ES_SAF400x

Errata sheet SAF400x

Rev. 0.6 — 10 October 2017

Info	Content
Keywords	Mercury, SAF400x, Errata
Abstract	This document describes deviations of the SAF400x release

Figure 2 Pin change ES1 and ES2

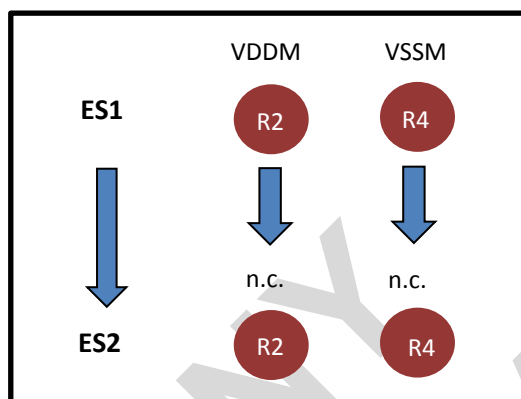
A power pair for VDDM (memory supply pins) will not be connected in ES2. Affected pins are R2 and R4. The figure below shows the different pinning between ES1 and ES2.

The memory power supply pair can result in interferences in AM, FM and DAB. These interferences can degrade the tuner performance.

Pins R2 and R4 are not connected in ES2. Board design for ES1 is compatible to ES2. Corner silicon for ES2 is being validated.

Figure 4 AM Wideband Noise Cancellation

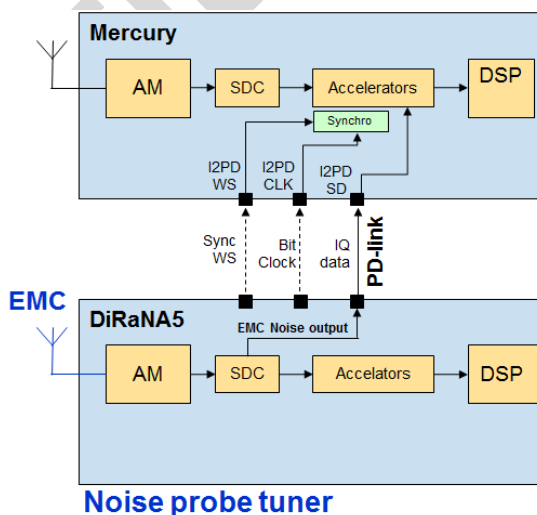
AM cancellation requires a noise probe (DiRaNA5 in diagram). In order to reduce the noise from an AM broadcast, Mercury subtracts the probe signal from the received AM signal.

The added hardware is available in Mercury ES2 to perform noise cancellation. Signal decimation is done in HW (using accelerators) as this is MIPS intensive. Cancellation is done in software on a DSP for flexibility and algorithm refinements. The I2PD interface is used for IQ data and control bits and synchronization is done in Mercury (in the set-up of Figure 4). The software is under development.

Note that Merlin is not compatible with this set-up.

Figure 5 Pin change ES1 and ES2

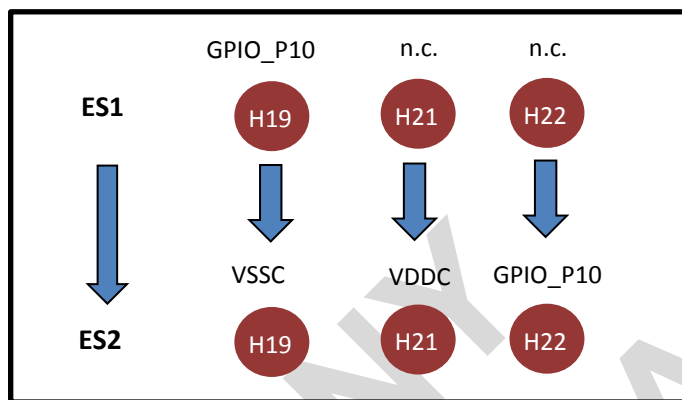
Mercury ES2 will have an additional power pair for VDDC_1V2. The affected pins: H19, H21 and H22.

- 1V2 supply needs to be between 1.19V – 1.25V (voltage on pin).
- Pin GPIO_10 cannot be used in ES1.
- VSSC/VDDC can be connected to H19/H21, but no current will flow over VDDC power lines in ES1

Board design for ES1 is compatible to ES2. The figure below shows the different pinning between ES1 and ES2.

The restriction on the supply voltage is relaxed (1.14V – 1.3V).

Pin GPIO_10 can be used in ES2.

Figure 6 BiQuad accelerator

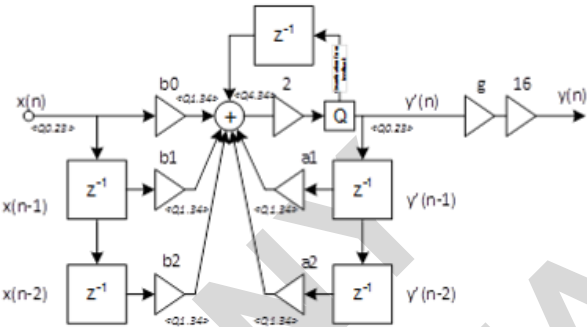
The following biquad implementation is available as special instructions on HiFi3 for ES2:

The added hardware is available in Mercury ES2. HiFi3 software for ES1 is compatible to ES2.

- without TIE instruction (C-library): 19 cycles
- with TIE instruction: 1 cycle (parallel operation)
